**Project #22-018
Wal Mart Fuel Station
Located at 1150 South 100 West**

REPORT SUMMARY...

<i>Project Name:</i>	Wal Mart Fuel Station
<i>Proponent/Owner:</i>	Kimley Horn Assoc. / Wal Mart Stores Inc.
<i>Project Address:</i>	1150 South 100 West
<i>Request:</i>	Design Review Permit
<i>Current Zoning:</i>	Commercial (COM)
<i>Date of Hearing:</i>	March 24 th , 2022
<i>Type of Action:</i>	Quasi-Judicial
<i>Submitted By:</i>	Russ Holley, Senior Planner

Figure 2 shows the proposed site plan

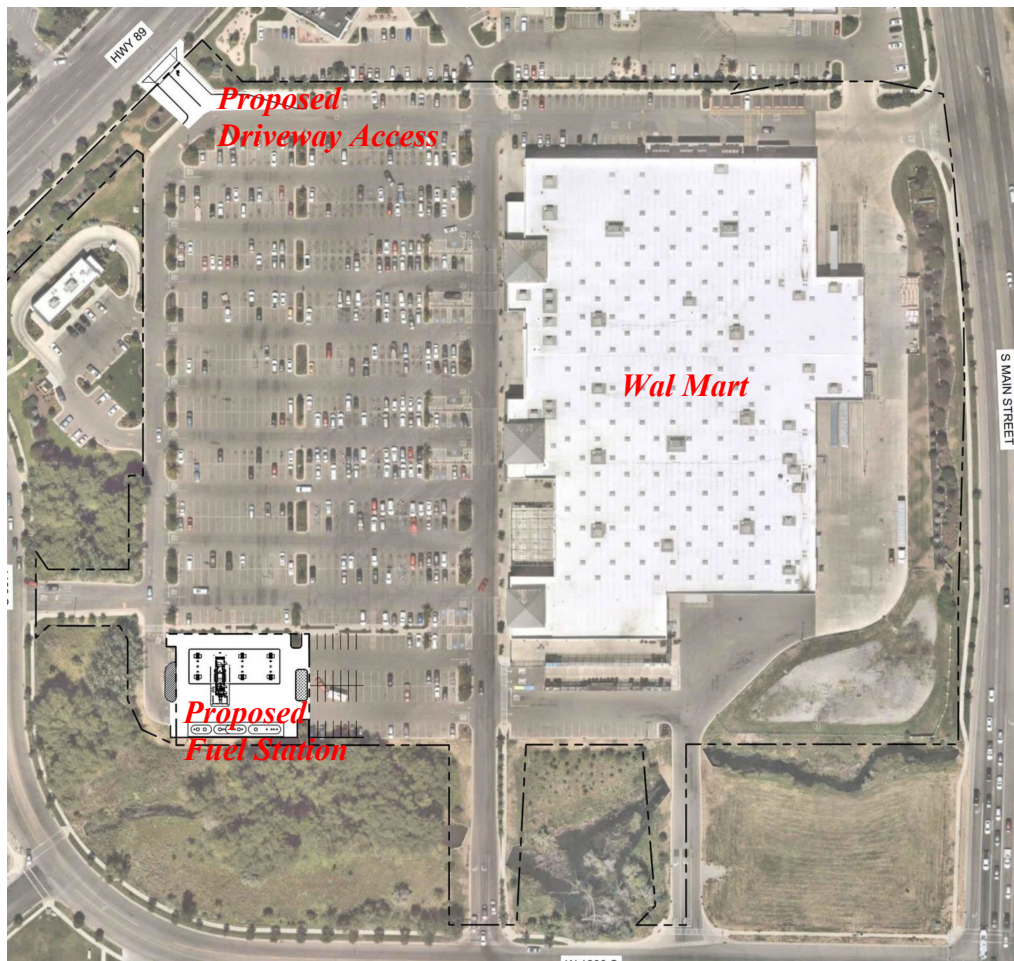
1. All standard conditions of approval will be recorded with the Design Review and are available in the Community Development Department.
2. The Utah Department of Transportation (UDOT) will need to approve the proposed north driveway onto HWY 89/91.

3. Open space and landscaping shall comply with LDC standards of 20 % and 20 trees per acre for either the overall site or just the 0.65-acre gas station location.

4. The sidewalk connecting the building to 100 West shall not be blocked or altered for this project.
5. The building and canopy design are approved as submitted.

DESIGN CIVIL SITE PLAN

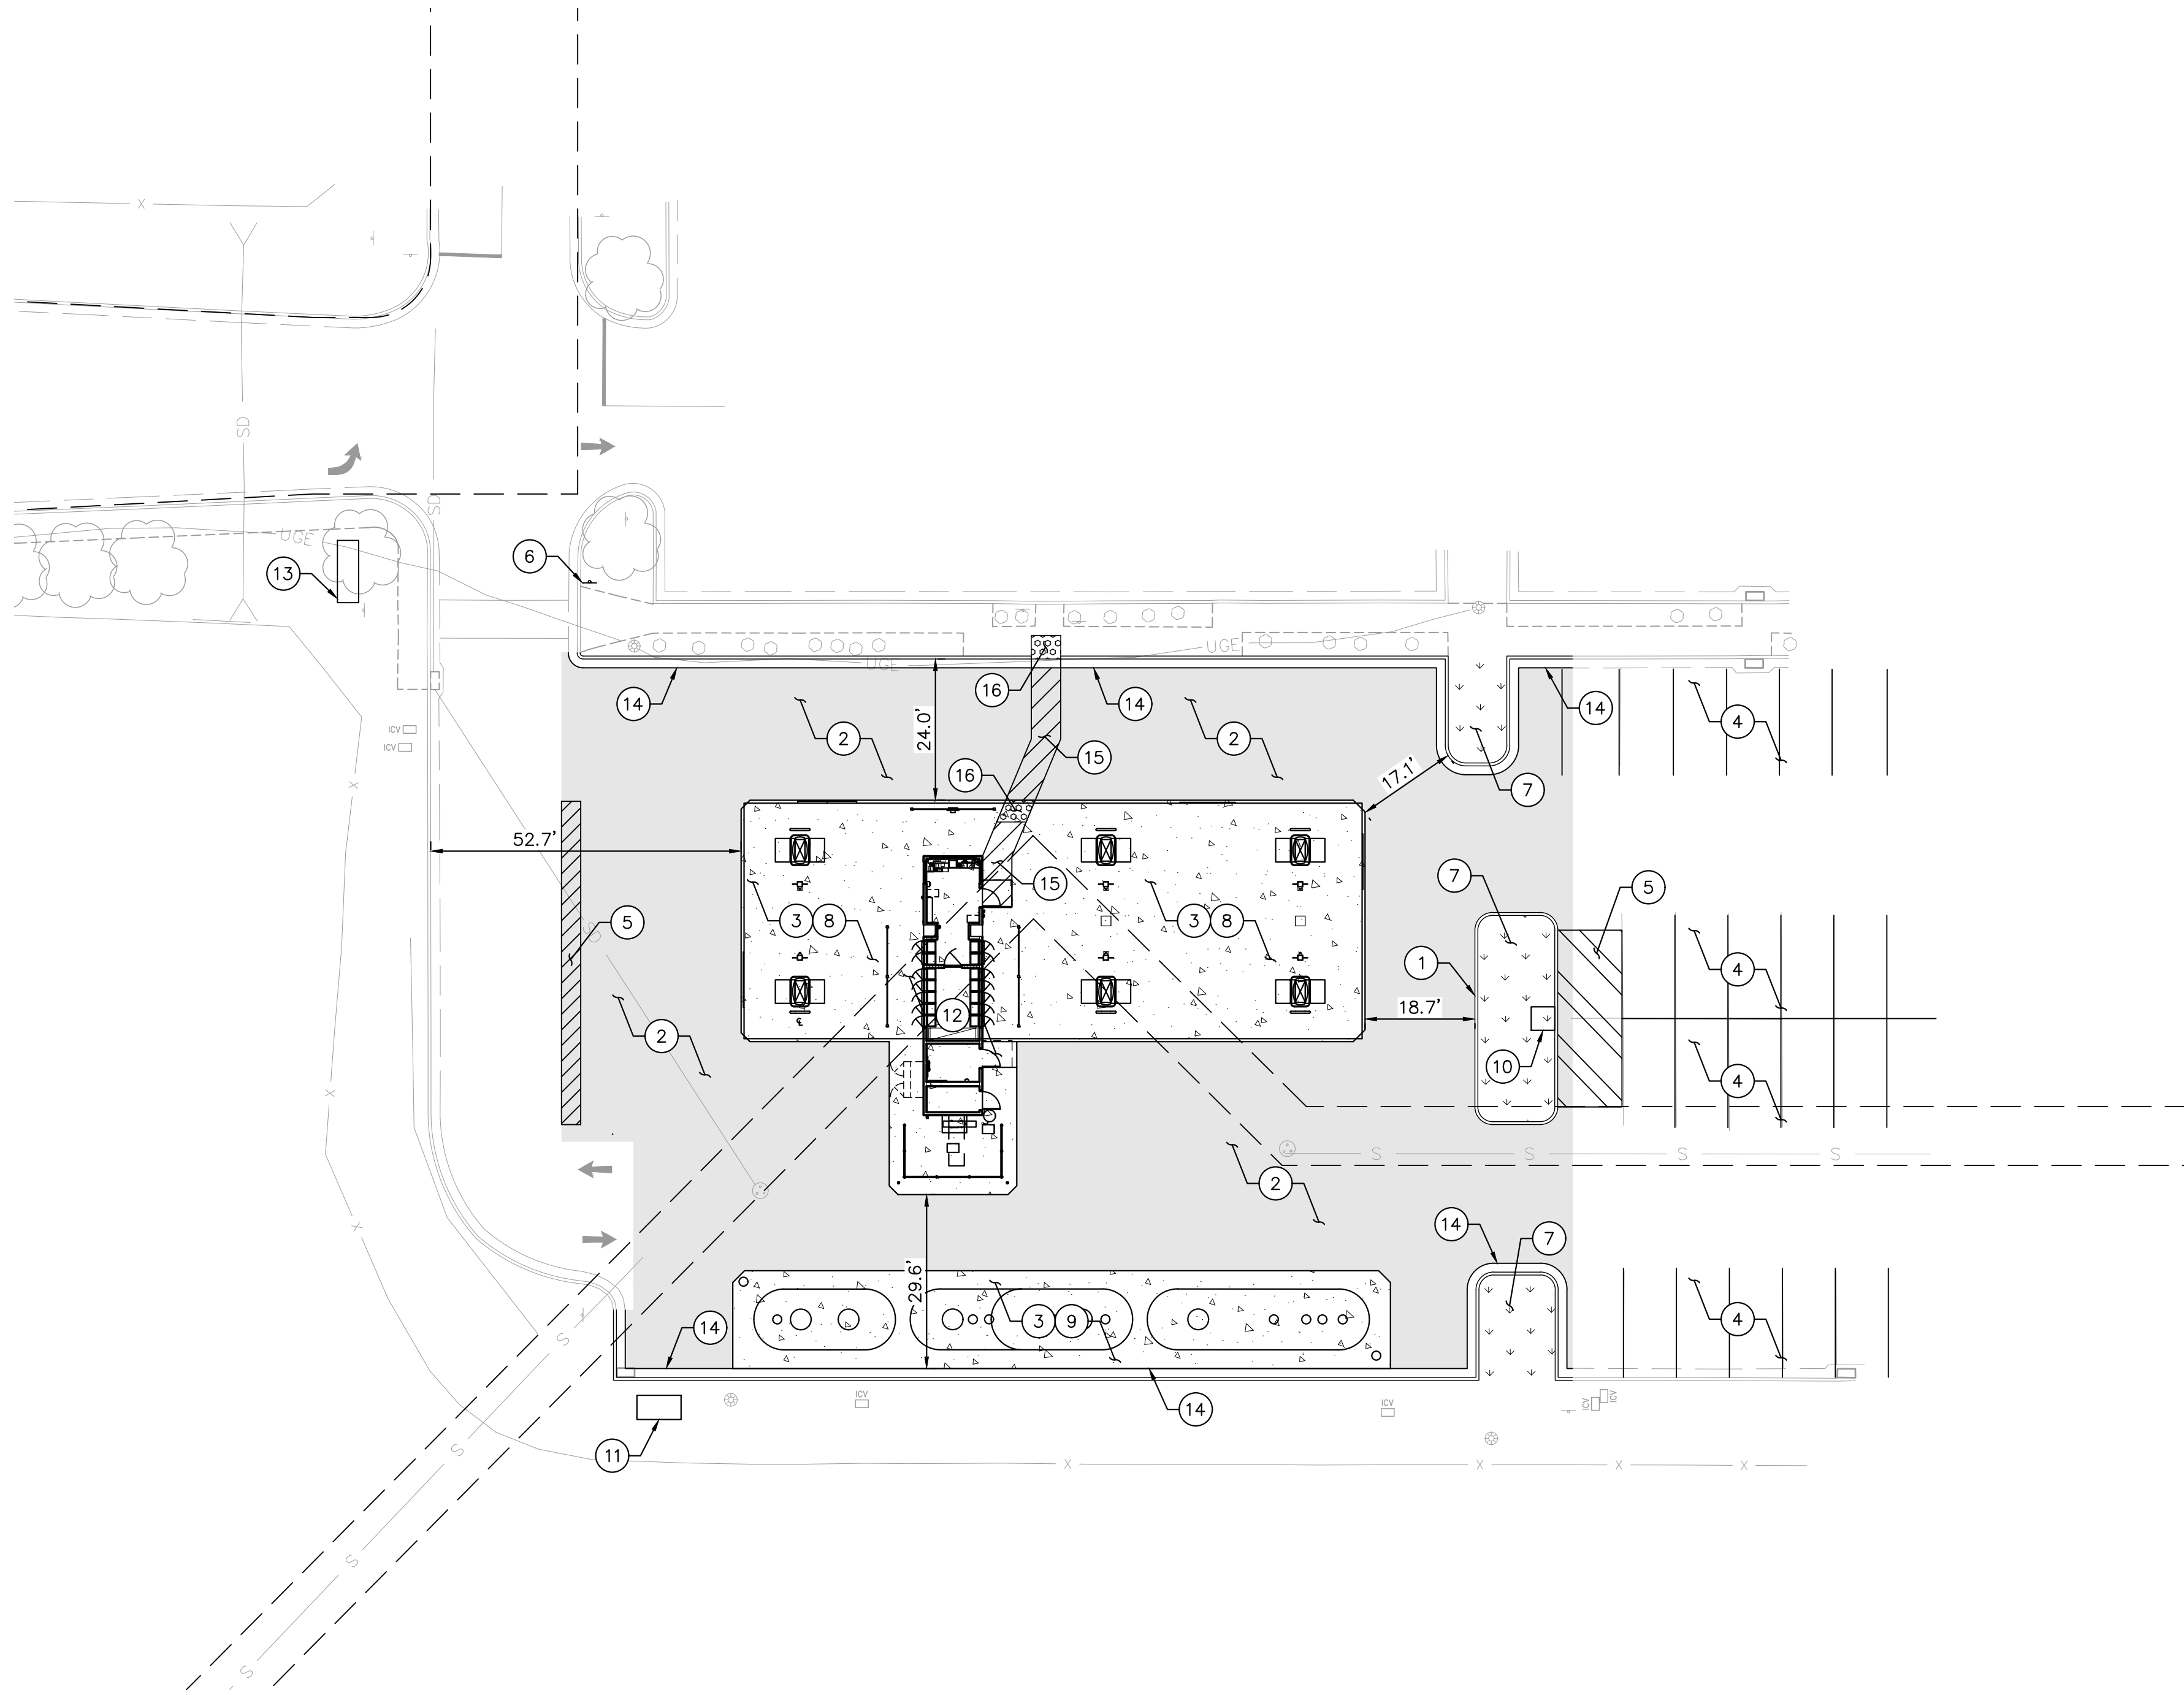
- a. *Environmental—contact 716-9760*
 - Garbage placement was not indicated on plans. Haul through the store to compactor or contact Environmental for possible alternatives.

- The site plan does not completely show existing utilities. A more complete review of plans will be performed at time of building permit application.
- The site plan shows a 1.5" water service. The City offers 1-inch or 2-inch meters. The waterline from the main to the meter must match the selected meter size. Water meter location shall be approved by Logan City.

- Site plan shows an oil water separator, however, plans provided do not show drainage area to the separator and associated collection, catch basins, and piping flow. At a minimum, all areas around the pumps needs to drain to the oil water separator.
